SERVICETEKNOTES

TABLE OF CONTENTS

Figure 1

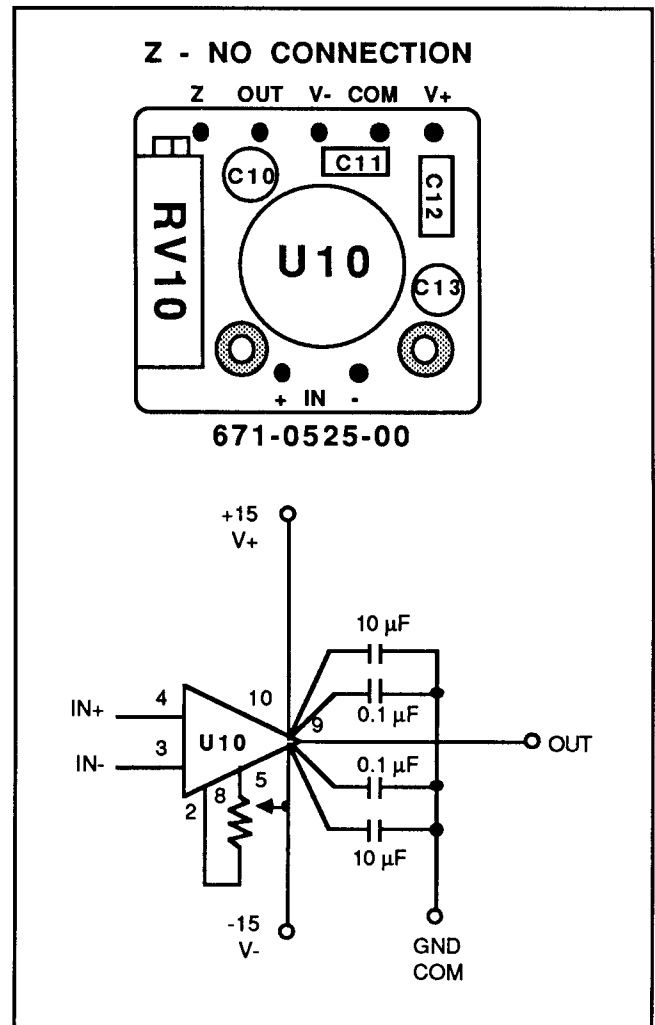
The second part of Mod #66798 is for replace-
ment of U250, the Burr-Brown module P/N
156-0370-00, which is no longer available from
the vendor. Additionally, the Burr-Brown
module did not supply enough output voltage
with relation to input current on the 100 mA
range. The replacement for U250 is a plug in
ECB P/N 671-0525-00. It includes an
AD382KH OP Amp P/N 156-3280-00. The
ECB is simply inserted in place of U250. The
offset adjustment, R140 will no longer be
functional, and may be removed from the
Amplifier board if desired. After the mod the
offset adjustment will be on the ECB and will be
labeled RV10.

U10	156-3280-00	AD382KH
C10	290-0536-00	10 μ F 25 V
C11	283-0421-00	0.1 μ F 50 V
C12	283-0421-00	0.1 μ F 50 V
C13	290-0536-00	10 μ F 25 V
RV10	311-1319-00	10K 15 Turn

After the modifications the part numbers will be:

670-2826-08
670-5479-05
670-7140-02
670-8668-01

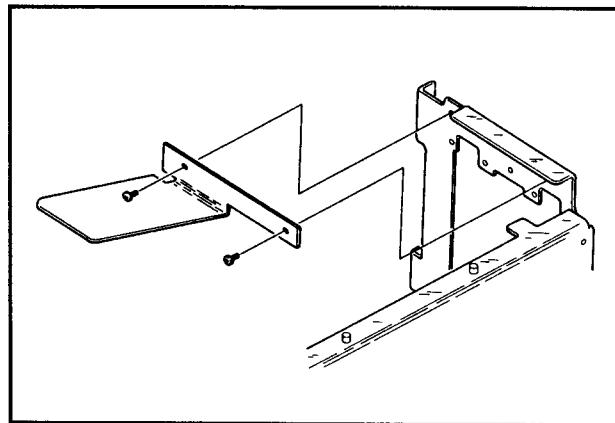
This procedure outlines the process of installing a new guide deflector into the 7612D. This new guide prevents damage to the 7612D Plug-in Interface should the plug-in amplifier be installed at an angle other than 90 degrees to the interface.

Remove the top cover of the 7612D.

Remove and discard the two machine screws identified by index number 73 (SCREW, MACHINE: 4-40 X 0.25, PNH, STL), these are located toward the rear and top of the chassis.
